**PLANNED UNIT DEVELOPMENT
& SUBDIVISION STAFF REPORT****Date: July 21, 2005****DEVELOPMENT NAME**

Louise Place Subdivision

Single-family residential Planned Unit
Development and subdivision with reduced lot sizes and widths.

SITE PLAN

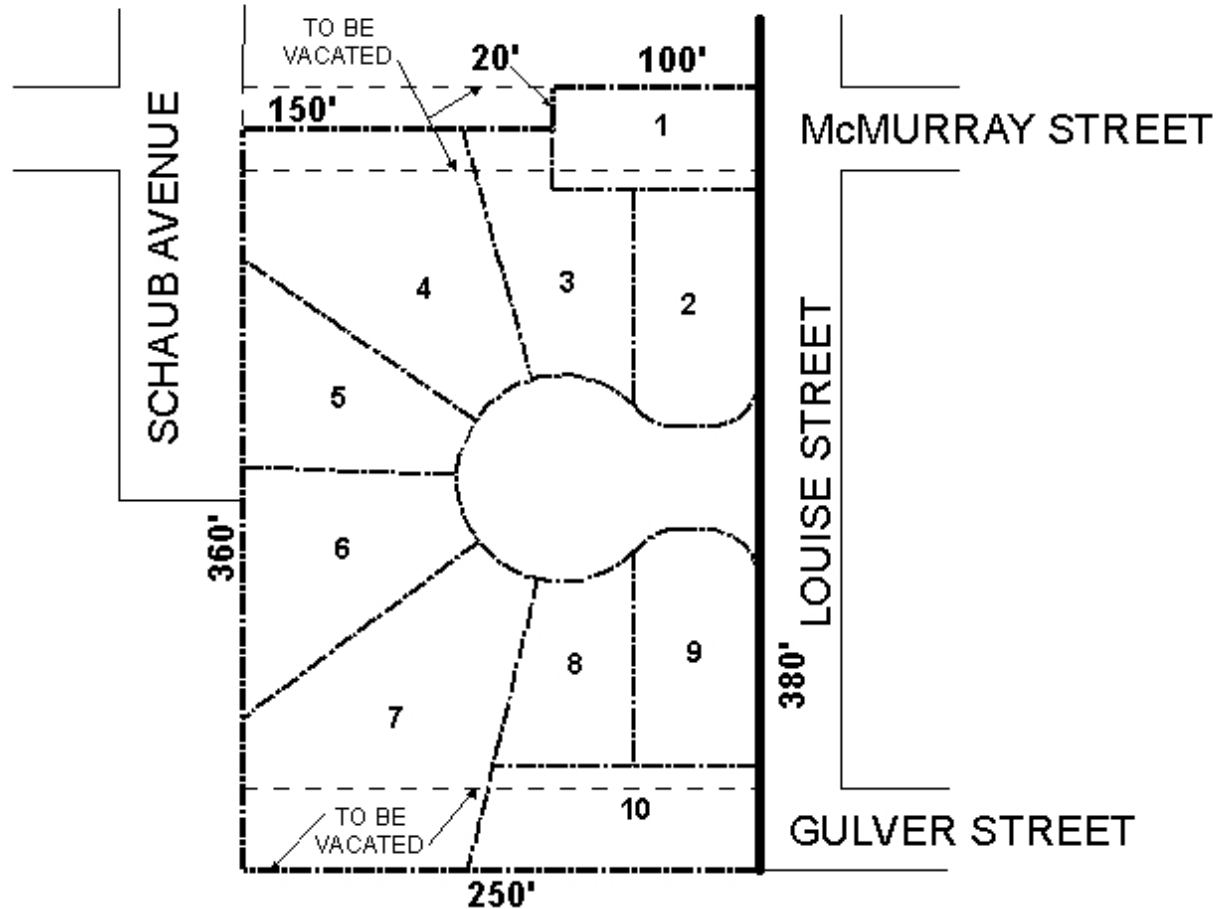
Must comply with all stormwater and flood control ordinances. Any work performed in the right of way will require a right of way permit. No stormwater detention area or Common Area for such is shown on the proposed plat. Stormwater detention is required for this development and should be shown on the plat.

Driveway number, size, location, and design to be approved by Traffic Engineering and conform to AASHTO standards. The radius of the cul-de-sac and roadway should be built to city standards.

The site fronts Louise Street, a 40' unopened right-of-way; as this is substandard in width, dedication of sufficient right-of-way to provide 25 feet from the centerline of Louise Street should be required. In addition, construction of this portion of Louise Street will be required, as will construction of the new cul-de-sac street, prior to signing the final plat; standards of street construction are to be coordinated with and approved by City Engineering. As the site involves several unopened rights-of-way, vacation of such will be required before the plat is recorded or any permits are issued.

Two of the proposed lots (Lots 1 and 10) would face Louise Street, and the remaining eight lots would face the new cul-de-sac street. The plat indicates 25' minimum building setbacks, which, with the required dedication, would leave proposed Lots 2 and 9, which are the corner lots leading into the cul-de-sac, with very narrow building sites. Even with a reduced (20') setback from Louise Street, the site would not have the minimum 30' wide building site (Section IV.D.3 of the Zoning Ordinance). Section V.D.1 of the Subdivision Regulations requires that every lot have a suitable building site. It should be

An additional concern regards the orientation of proposed Lot 10. While orientation toward Louise Street is consistent with the original plan for this portion of the Pinehurst Subdivision, with the proposed cul-de-sac development, Lot 10 would be the sole property oriented this way on this portion of Louise Street. Both of its side yards would abut the rear yards of other properties, and for this reason it would not seem that the "*orientation...shall be appropriate to the location of the subdivision*", as required by Section V.D.1 of the Subdivision Regulations.

While reduced lot sizes and lot widths may be appropriate for the area, the issues of suitable building sites (for proposed Lots 2 and 9) and orientation (for proposed Lot 10) should be addressed in a redesign of the project. This may necessarily decrease the number of lots that can be created.

RECOMMENDATION Based on the preceding, this application is recommended for Holdover until the August 4th Planning Commission meeting, to allow the applicant to submit revised drawings addressing the following concerns: 1) depiction of the right-of-way dedication for Louise Avenue; 2) depiction of the minimum building setback lines, and; 3) depiction of adequate buildable area for the proposed lots, as there has been no request for an increase in permitted site coverage or reduced setbacks.
